OYSTER CREEK NUCLEAR GENERATING STATION, UNIT NO. 1

AMENDMENT TO PROVISIONAL OPERATING LICENSE

Amendment No. 32
License No. DPR-16

SAFETY EVALUATION BY THE OFFICE
 OF NUCLEAR REACTOR REGULATION SUPPORTING
 PROPOSED CHANGES TO THE TECHNICAL
 SPECIFICATIONS ASSOCIATED WITH THE
 SHORT TERM PROGRAM'S PLANT UNIQUE
 ANALYSIS FOR MARK I CONTAINMENTS
 AND
 AMENDMENT NO. 32 TO LICENSE NO. DPR-16
 JERSEY CENTRAL POWER & LIGHT COMPANY
 OYSTER CREEK NUCLEAR GENERATING STATION
 DOCKET NO. 50- 219

DOWNCOMER SUBMERGENCE, FT.
FIGURE 3.5-1

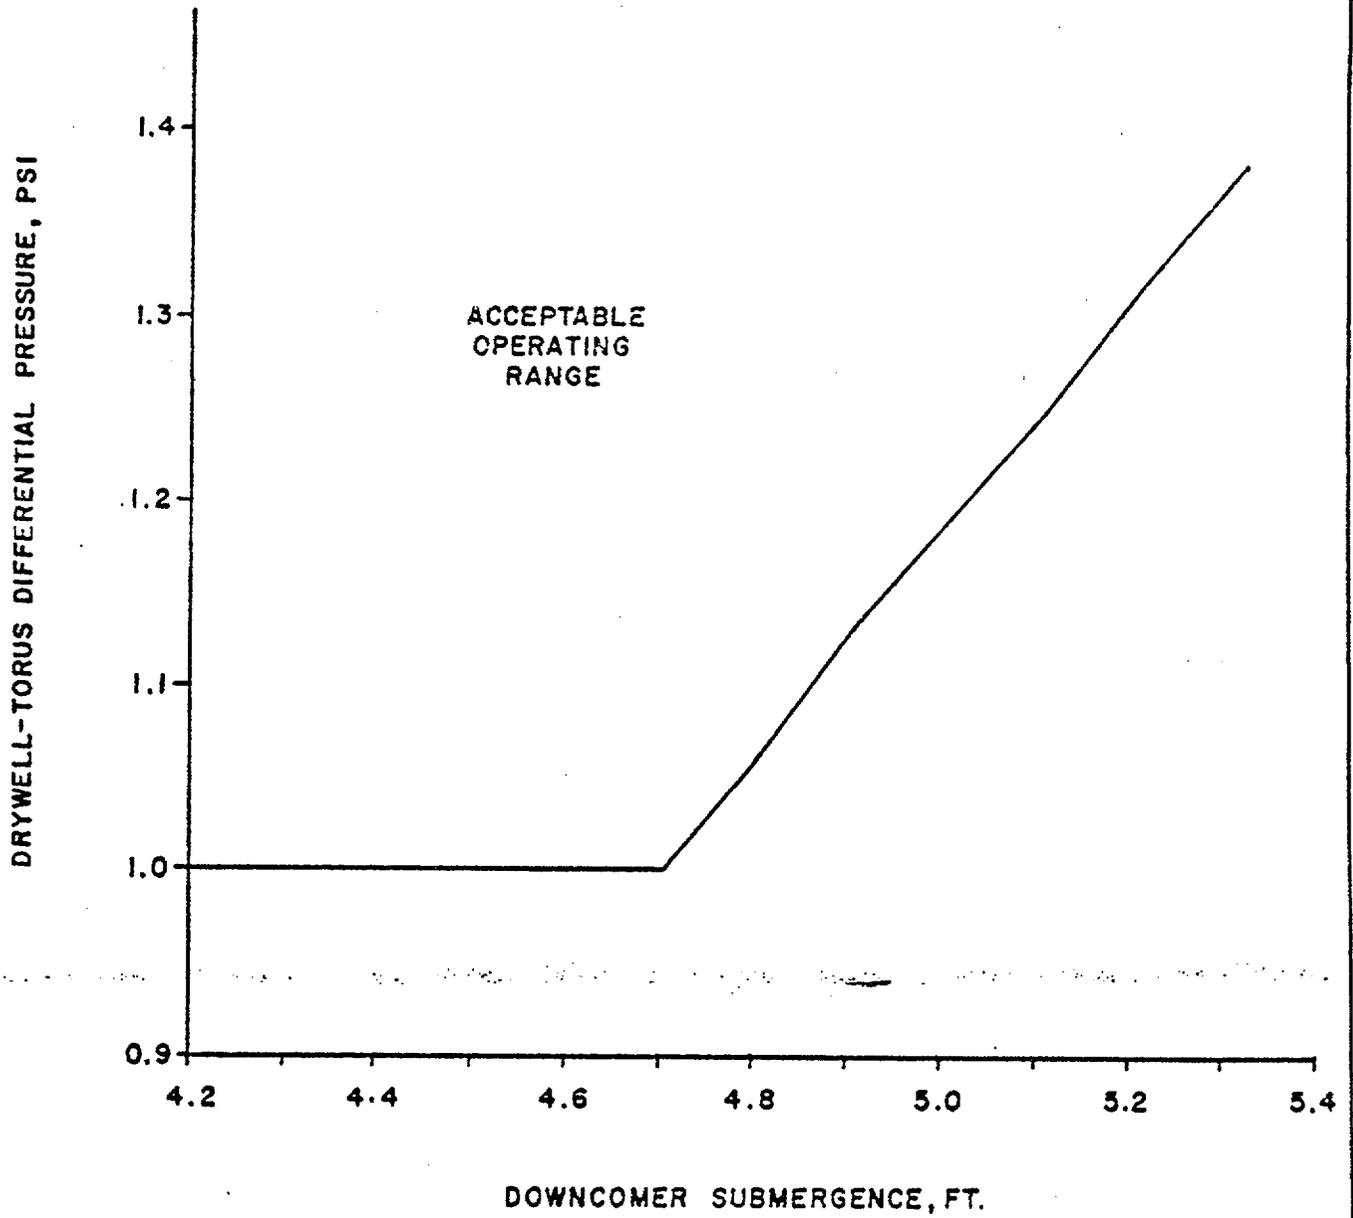
9. Drywell-Suppression Chamber Differential Pressure
 - a. Differential pressure between the drywell and suppression chamber shall be maintained within the acceptable operating range shown on Figure 3.5-1 within 24 hours after the reactor mode selector switch is placed in the run mode. The differential pressure may be reduced to less than the range shown on Figure 3.5-1 24 hours prior to a scheduled shutdown. The differential pressure may be decreased to less than the required value for a maximum of four hours during required operability testing of the drywell-pressure suppression chamber vacuum breakers.

- b. If the differential pressure of Specification 3.5.A.9.a cannot be maintained, and the differential pressure cannot be restored within the subsequent 6 hour period, an orderly shutdown shall be initiated and the reactor shall be in the shutdown condition within the next 6 hours and the cold shutdown condition within the following 18 hours.
